City of Encinitas
City Council
May 23, 2018

Development Standard Review

Height Standards

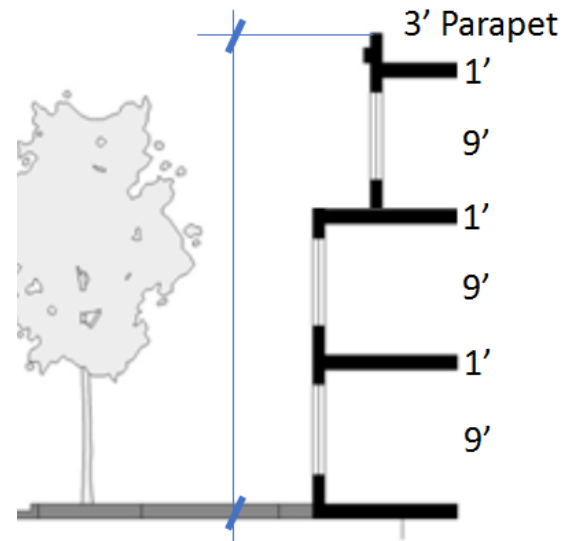
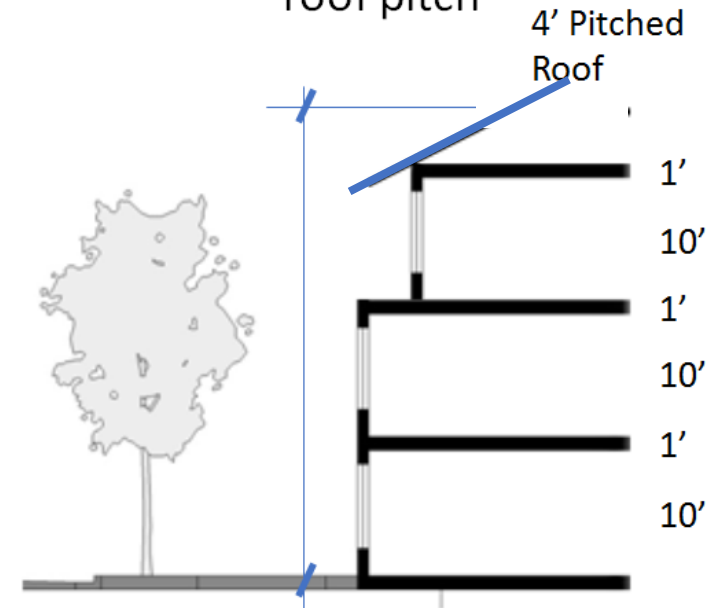
Planning Commission Comments:

- 30-foot top of plate
- Additional 4-feet for pitched roof
- Additional 3-feet for parapet

RECOMMENDATION:

- Maintain recommendation
- Allows increased ceiling height
- 3-Story/33-feet flat roof
- 3-story 37-feet for pitched roof

Measurement Standard – Encroachments

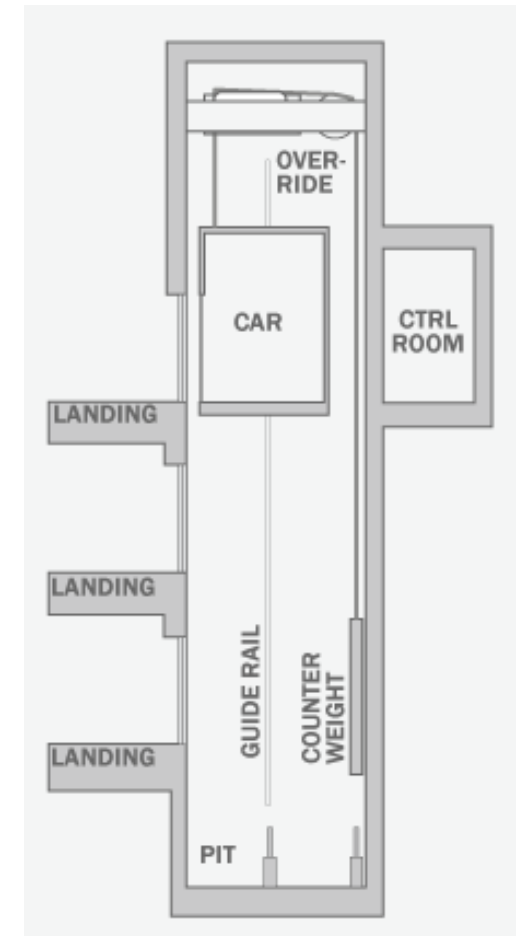
Planning Commission Comments:

- Height increase only if specific criteria are met
- Some Commission members against any additional height
- Some Commission members expressed no need for roof top facilities

RECOMMENDATION

- Appurtenances may exceed height by 5'
- Height extension may not occupy more than 25% of roof area
- Height extension must be set back 10' from the edge of the roofline

Wall Stepbacks Standards

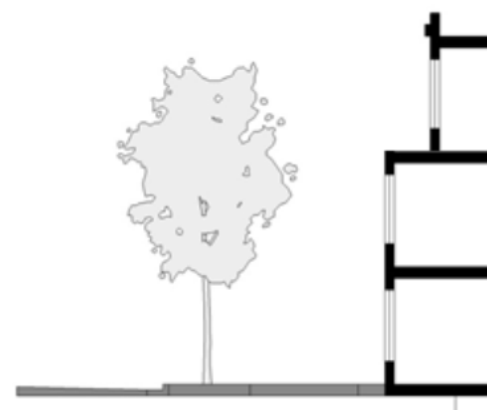
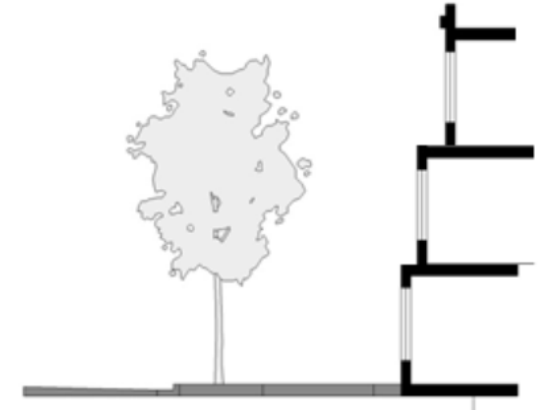
Planning Commission Comments:

- Consider having additional 3rd floor perimeter setback or percentage of top floor allowing 3rd floor to go to min. setback depending on what is adjacent
- Review Measure T for 3rd floor coverage – 70%

RECOMMENDATION:

- Maintain original recommendation
- 5-foot minimum aggregate stepback
